Office Action Summary	Application No. 10/748,542	Applicant(s) FANDEL, RICKEY L.	
	Examiner William V. Gilbert	Art Unit 3635

DETAILED ACTION

Claims 1, 2, 4, 6-9, 11-14, 17, 19, 21, 22 and 24-28 are rejected under 35 U.S.C. 102(b) as being anticipated by Weckerly (U.S. Patent No. 3,256,650).

Figure 2 from Weckerly

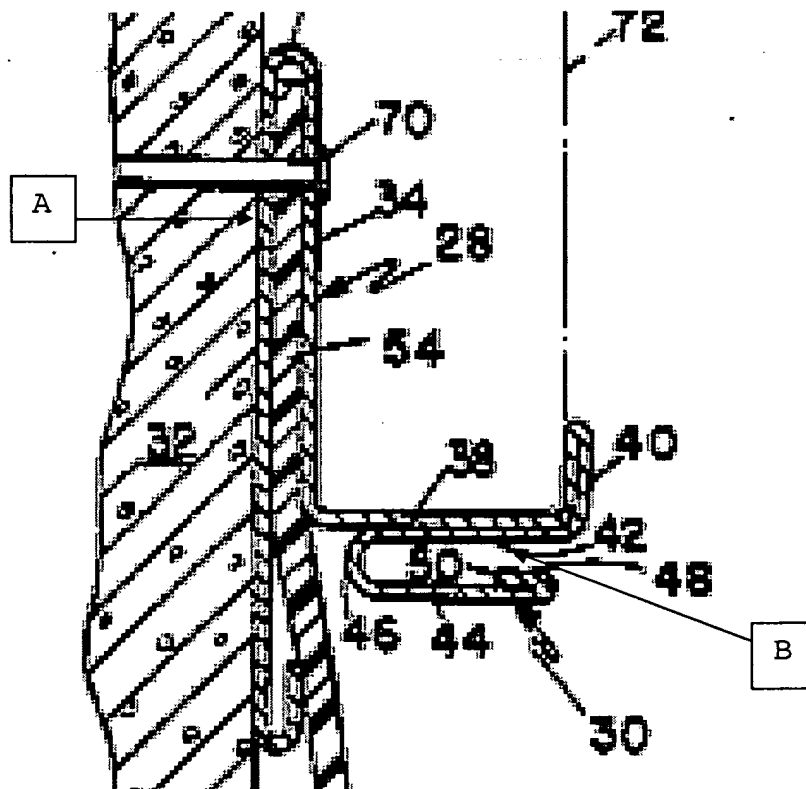
Claim 1: Weckerly discloses a flashing receiver (20) comprising a thin gage material having first and second legs (see "A" and "B" respectively from Figure 2, below from Weckerly), the first leg is not parallel to the second leg (see portion 42), the first leg has a height and extends longitudinally, the second leg has first and second sides, the first side is associated with a wall covering (72; portion proximate 40 is associated with the covering), and the second side is associated with a removable flashing (52; see Fig. 3), an intermediate member (34) offsetting the first and second legs, and a J-shaped channel (40, 42, 46, 44, 48) that has a bottom (44) and outer extension (40) that is parallel to an entirety of the height of the first leg and the first leg extends at least as far as said bottom of the J-shaped channel.

Claim 11: the J-shaped channel (portions 34, 38 and 40) is at a height above the bottom.

Claim 13: Weckerly discloses a flashing receiver (20) comprising a thin gage material having first and second legs ("A" is the first leg and 34, 38 and "B" form the second leg, above), the first and second legs are not parallel (portion 42 is not parallel), the first leg has a top and bottom and extends longitudinally, a portion of the second leg forms a J-shaped channel (40, 42, 46, 44), the second leg has a first side associated with a wall covering (72) and a second side associated with a removable flashing (52), a plurality of nail slots (formed by 70) extending through the first and second legs and proximate the top, and an intermediate member (36) offsetting the first leg from the second leg, the intermediate

member is resilient, the J-shaped channel has an outer extension (40) parallel to the first leg and the parallel portion of the first leg extends at least as far as a bottom of the J-shaped channel.

Claim 26: Weckerly discloses a flashing receiver comprising a thin gauge material having a first and second leg ("A" and "B" respectively), the two legs are not parallel, the first leg having a first extend in a first direction and a longitudinal extent forming a mounting face, the second leg has first (proximate 40) and second (42) sides, the first side is associated with a wall covering (72) and the second side is associated with a removable flashing (52), an intermediate member (36) offsetting the first leg from the second leg, a J-shaped channel (40, 42, 46, 44) in the second leg having a bottom (44) and outer extension (40) that is parallel to an entirety of the extent of the first leg in the first direction, the extent of the parallel portion is the first leg extends at least as far as said bottom of the J-shaped channel.
